## TEXAS COMMISSION ON ENVIRONMENTAL QUALITY

Re: Edwards Aquifer, Comal County

Name of Project: Dry Comal Creek Vineyards; Located at 1741 Herblin Rd., approximately 0.30 miles south of the Herblin Rd and SH 46 intersection near Cranes Mill Rd; Comal County, Texas

Type of Plan: Request for Approval of a Water Pollution Abatement Plan (WPAP); 30 Texas Administrative Code (TAC) Chapter 213 Edwards Aquifer

WATER POLLUTION ABATEMENT PLAN  
SITE PLAN  
2011 OCT 10 PM 2:57  
ST. REGION

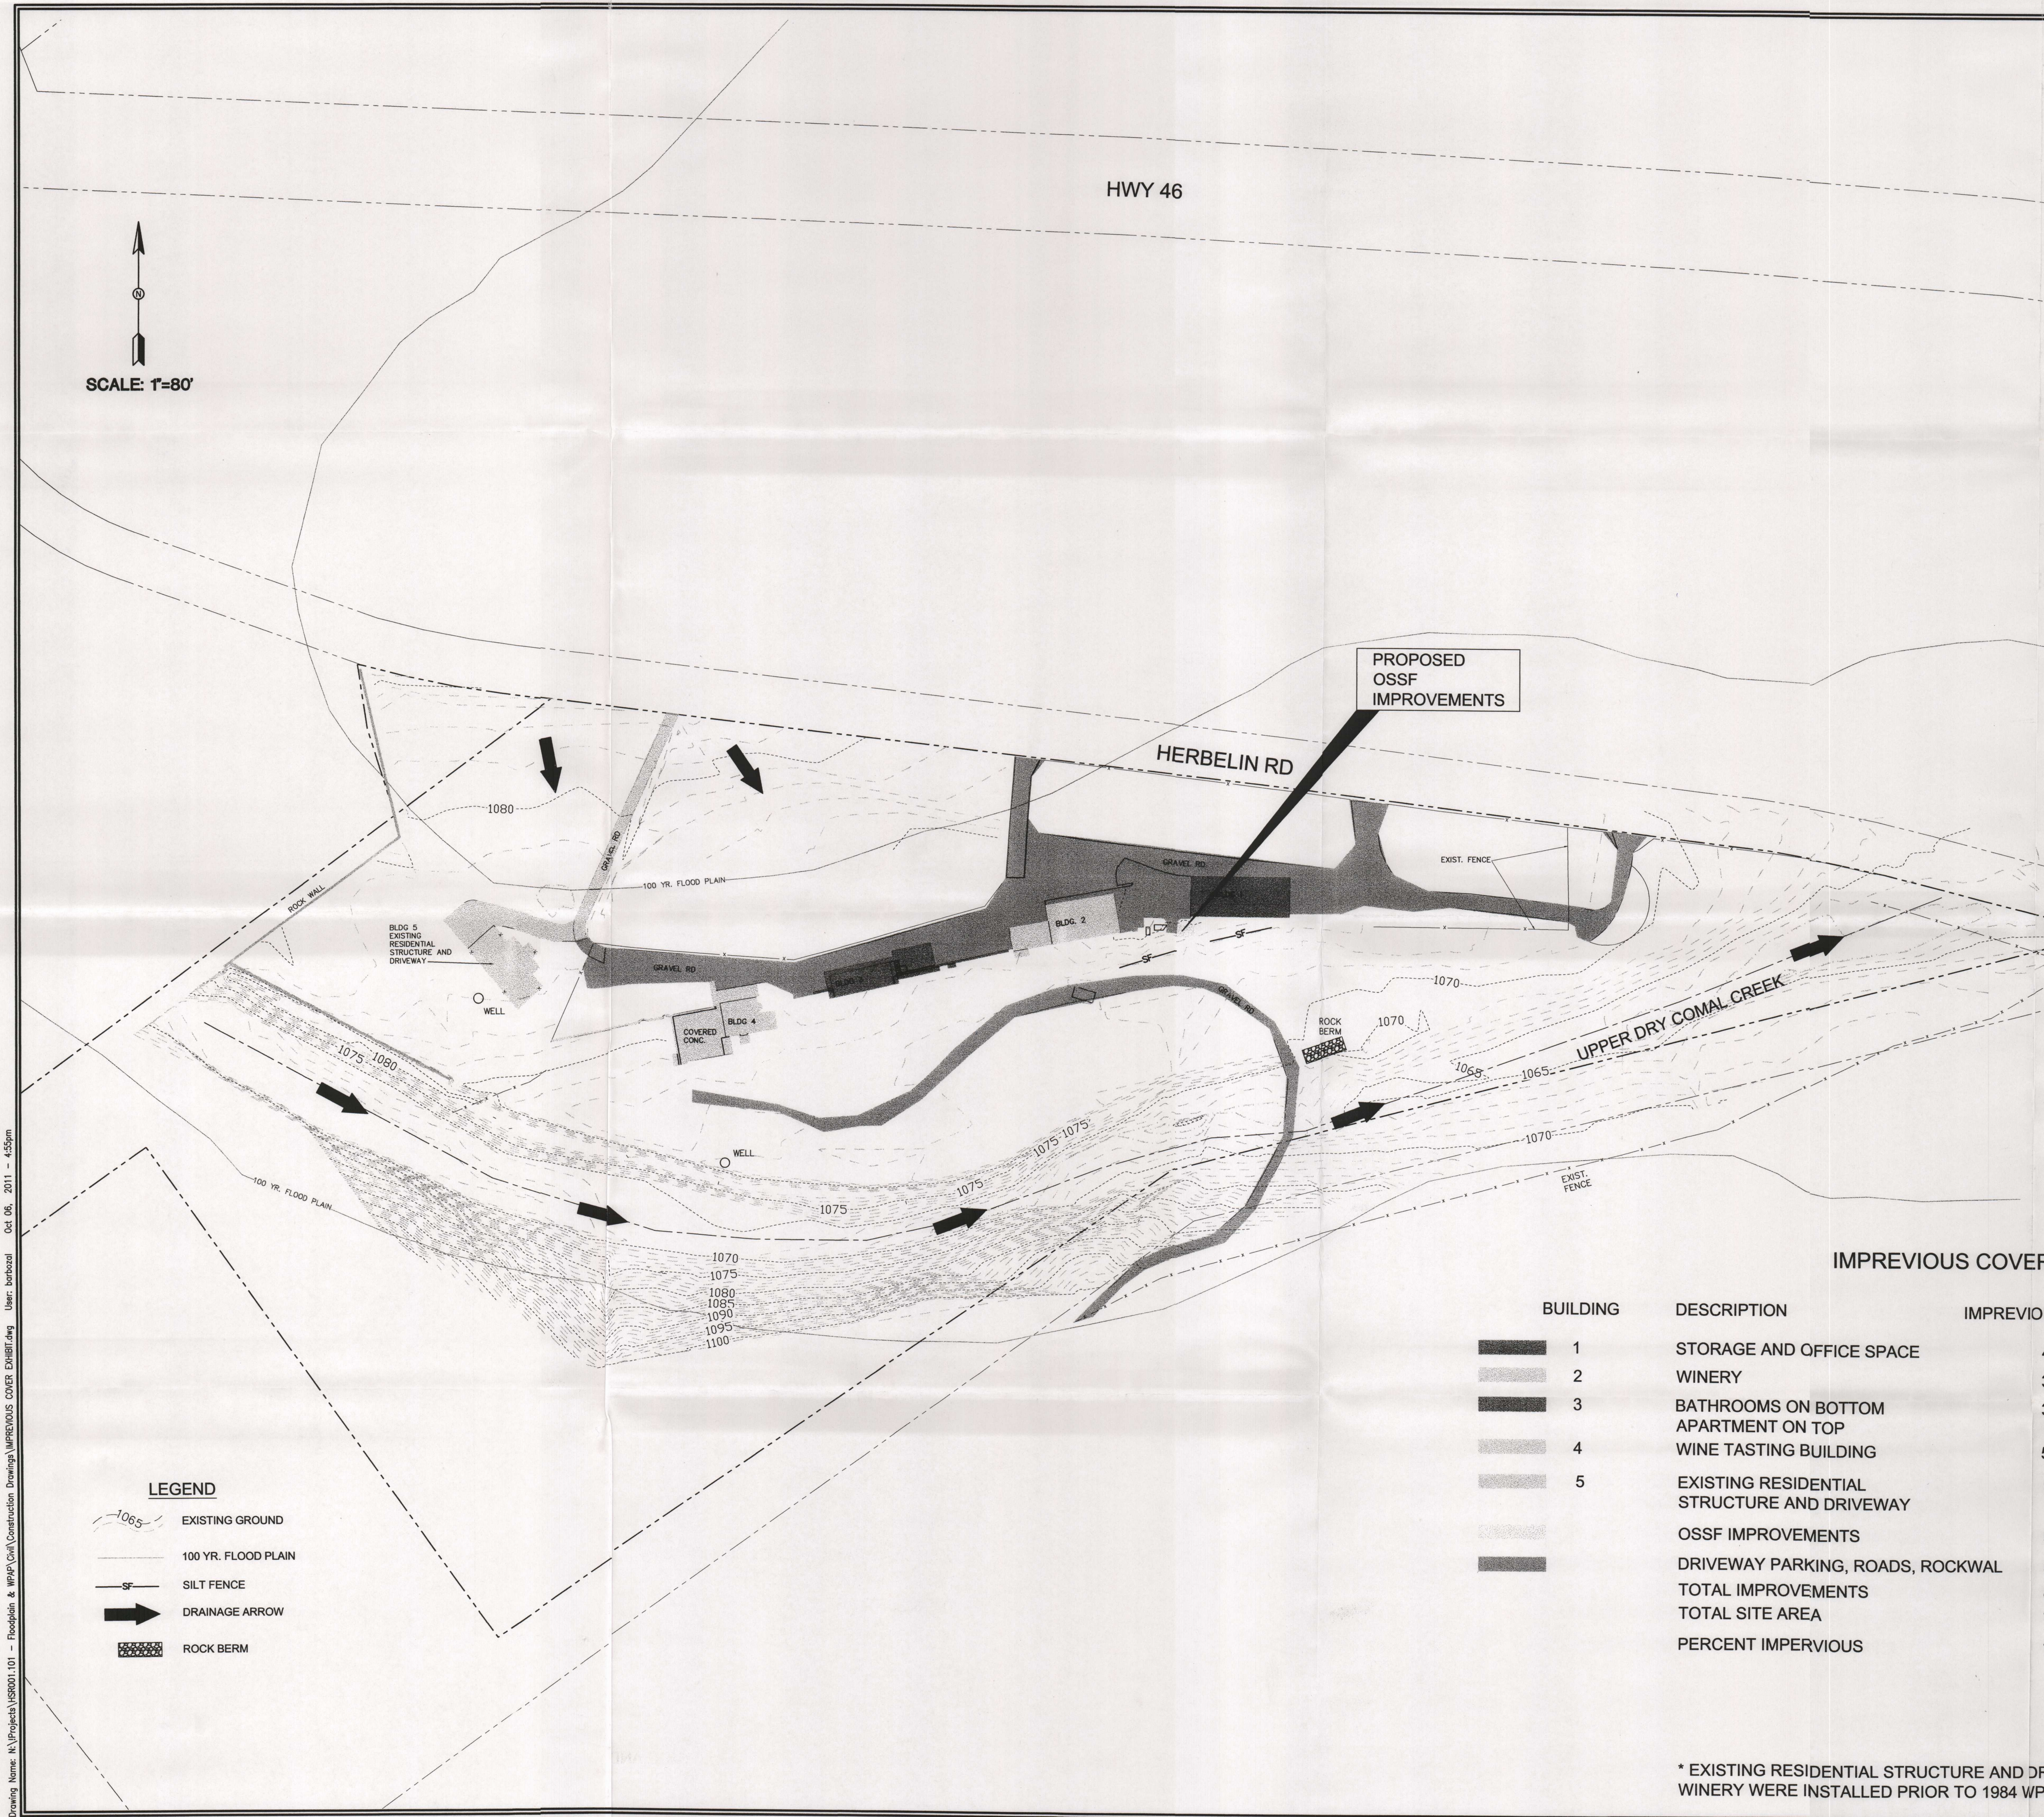
6. Update Site Plans & Geological Assessment to match the 18.44 acres.

**The Site Plan and Geological Assessment have been updated to include the 18.44 acre site.**
